Residential Engineering Services, P. A.

March 21, 2009

The purpose of this letter is to address five structural items noted on the home inspection report prepared by ERI Inspection Services (dated 3/6/09) for the property you are purchasing at #293 Pinewood Circle in Fleetwood, North Carolina. A field inspector from our company visited the property on March 19th to visually inspect, measure, and photograph the areas of concern.

Field Sketch

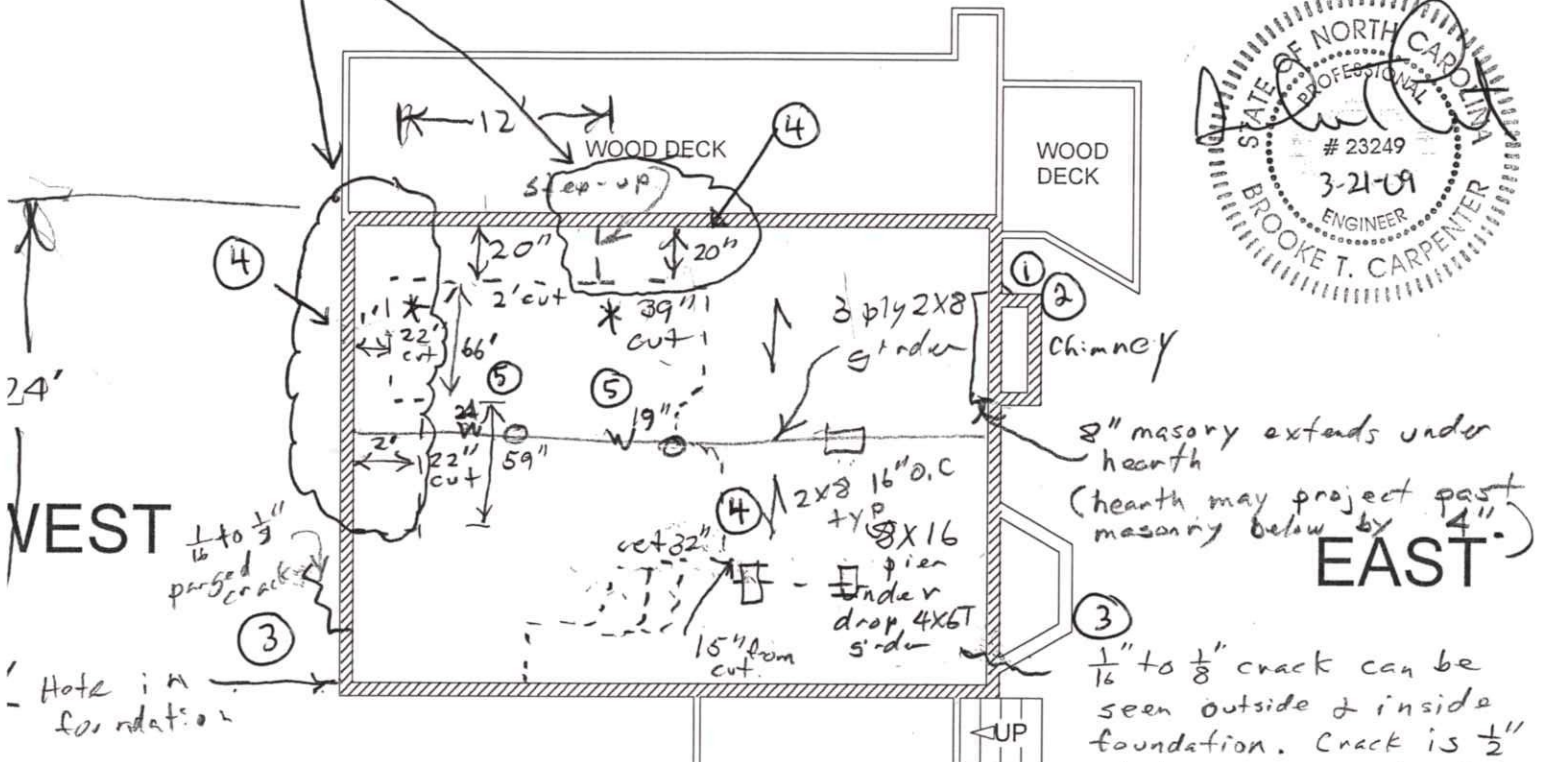
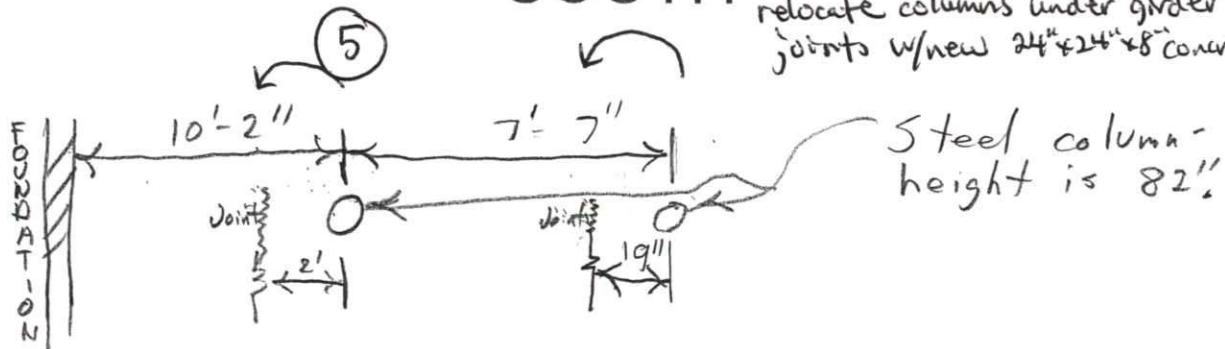
Circled areas require repair w/ soil cuts by foundation

All 3 members of 2x8 girder do not load of 4 1/2" steel columns. 2 piers were removed from these joints due to over dig. center

1/16" to 1/8" crack can be seen outside & inside foundation. Crack is 1/2" at top where mortar fell out of head joint. See photo.

relocate columns under girder joints w/ new 24" x 24" x 8" concrete footings
